## Response to Reviewer 1

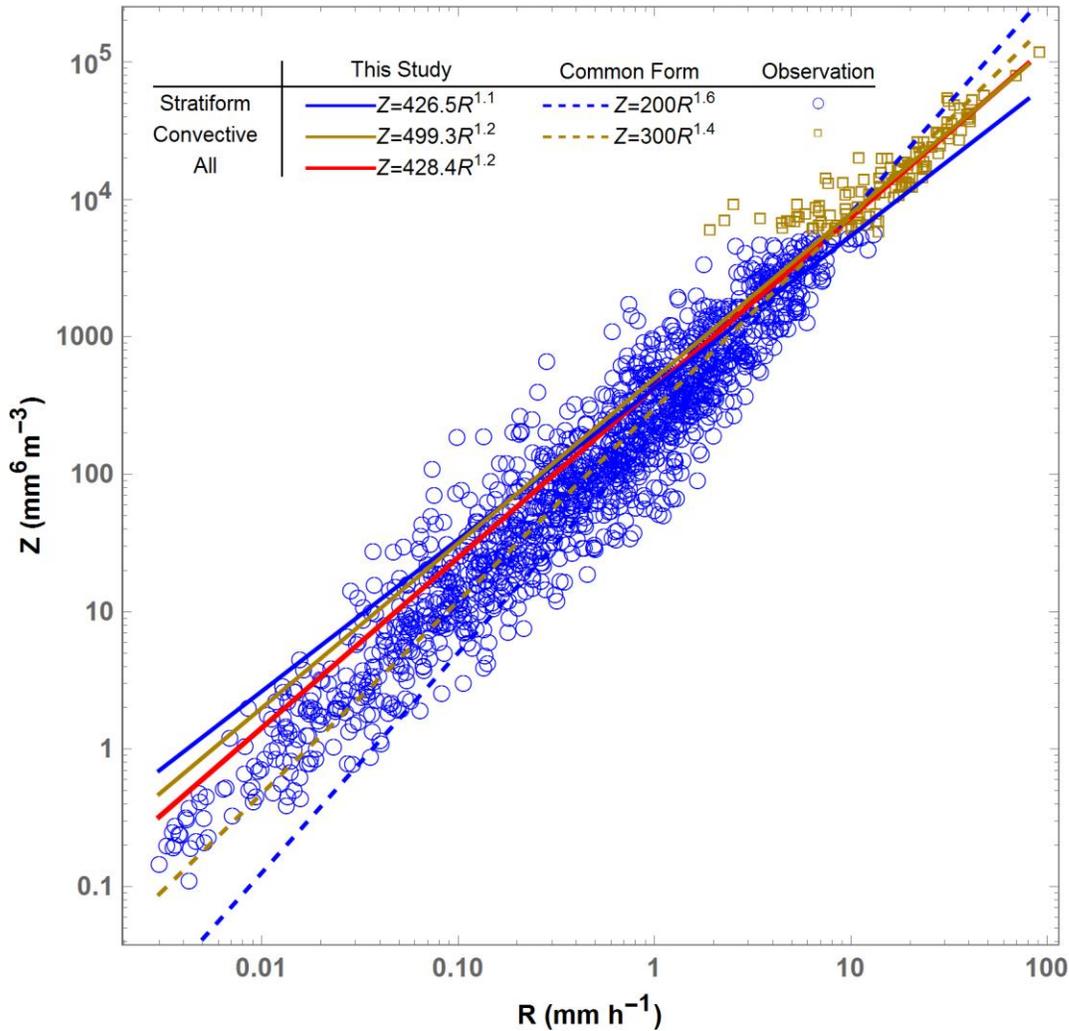
6. Fig. 5: the mustard-colored and red lines have the same exponent (1.2) but different slopes in the plot. On the other hand, the blue and red lines show different exponents but seem to have the same slope. Looks like the coefficients are switched somewhere

**Response:** We thank the reviewer for pointing out our mistake in the plot. We confuse the coefficients of “all” Z-R relation and Stratiform Z-R relation in this figure. The revised figure is shown blow. Despite the above analysis, since our convective/stratiform partition method is insufficient, the Z-R relation for both stratiform and convective rainfall is inappropriate, that means we still need to replot the figure in our revised manuscript.

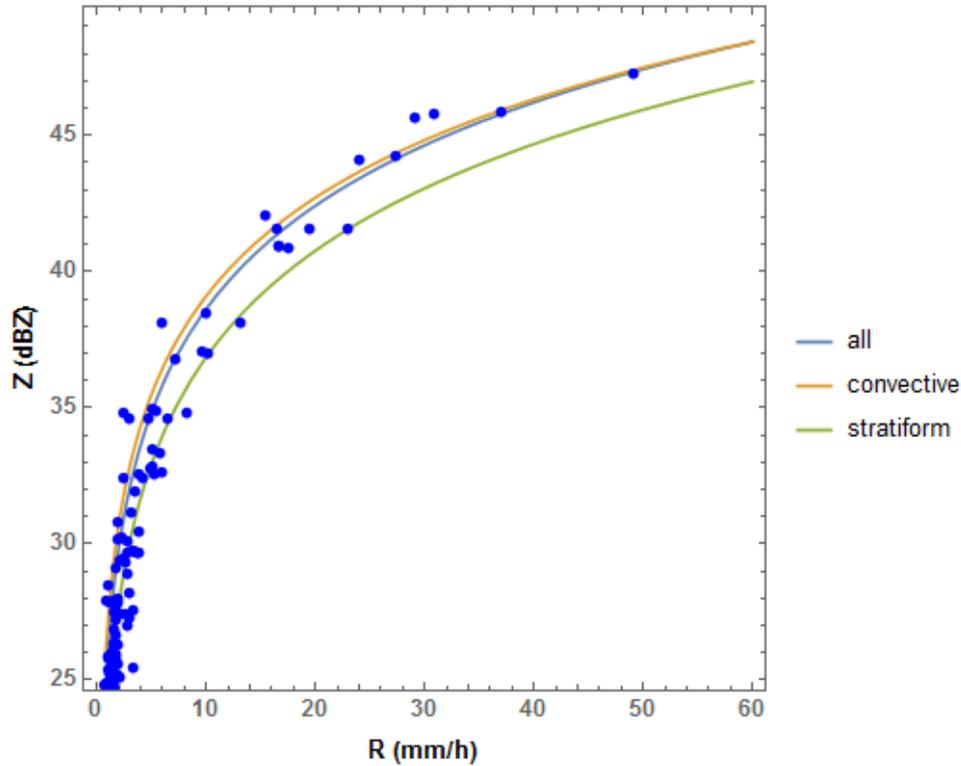
7. Fig. 8: the result in panel (e) appears a bit counter-intuitive, since the “all” Z-R relation should over-estimate always respect the convective relation and also respect to the stratiform relation, for R higher than approx.. 1 mm/h. The scatterplot shows the opposite. This might be related with the Z-R coefficients issue (previous point).

**Response:** We have double-checked that the plot is correct based on the Z-R relationships used in the previous manuscript. The reviewer suggested that “all” Z-R relation should over-estimate both respect the convective relation and also respect to the

stratiform relation. However, from the figure blow, we can clearly see that “all” Z-R underestimate the respect the convective relation. Therefore, using the “all” relation will underestimate the convective events like what is shown in our fig 8. Despite the above reason, since our convective/stratiform partition method is insufficient, the Z-R relation for both stratiform and convective rainfall is inappropriate, that means we still need to replot the figure in our revised manuscript.
